PLANNING, ZONING, & BUILDING DEPARTMENT  
PZ&B Staff Combination Memorandum: Architectural Commission and Town Council

SUBJECT: ARC-23-064 (ZON-23-054) 1473 N OCEAN BLVD (COMBO)

MEETING: OCTOBER 25, 2023

**Existing west façade of primary structure**

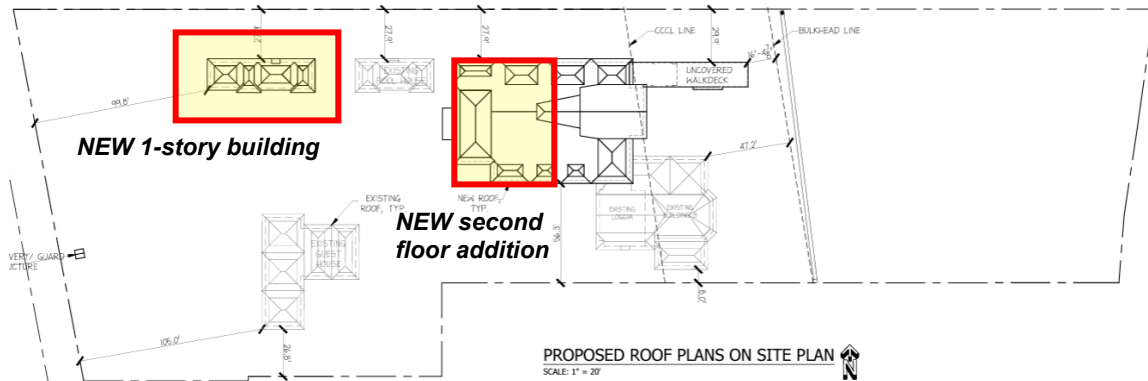
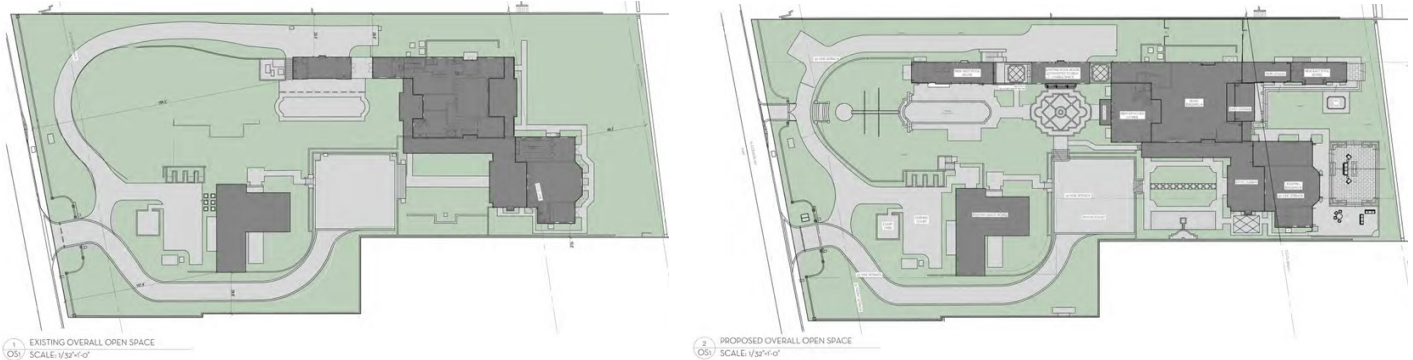
The main structure, centrally located on the site is proposed to have a second story addition over the existing main massing, and a one-story wing with uncovered 2<sup>nd</sup> story terrace proposed to expand easterly towards the ocean. Moving west along the northern setback line, an existing garage structure is proposed to remain, and new detached cabana building is proposed to the east, closest to North Ocean Boulevard. An accessory structure connected to the primary structure via a covered loggia is proposed to remain as-is but will require revesting of the nonconforming south side setback. Modifications to fenestration are proposed throughout.

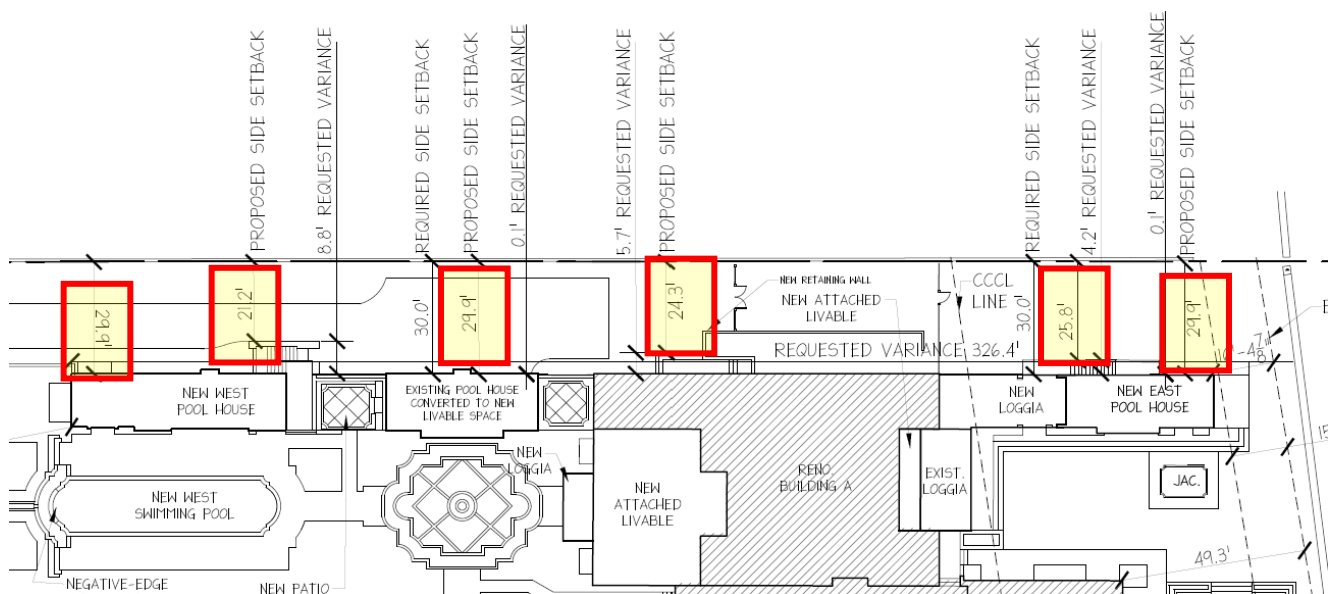
As it pertains to **Variance 1**, the applicant is applying for a north side-yard setback of 21.2' in lieu of the 30' required. Since the applicant is proposing to remove the primary structure's roof to accommodate the new second floor addition, more than 50% of the structure is proposed to be demolished, all of the nonconforming setbacks must be retested. The north side setback requirement is 30'-0" and the proposed additions, as well as the existing nonconforming elements proposed to remain, have a varying amount of setback encroachment, ranging from 29.9' to 21.2' at its most extreme. At minimum, the new construction of the new detached structure and new second floor addition should comply with the setback regulations.

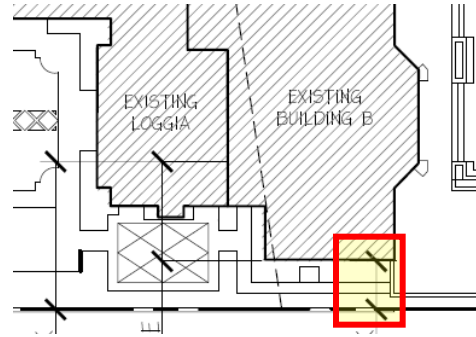
As it pertains to **Variance 2**, the applicant is seeking a south side-yard setback variance to permit a 10'-0" setback in lieu of the 30'-0" required. As mentioned above, the applicant must revest both setbacks as it pertains to the nonconforming side setbacks of the existing primary structure. The existing southern portion of the primary structure contains a nonconforming south side setback of 10'-0". No new additions are proposed to this portion of the residence.
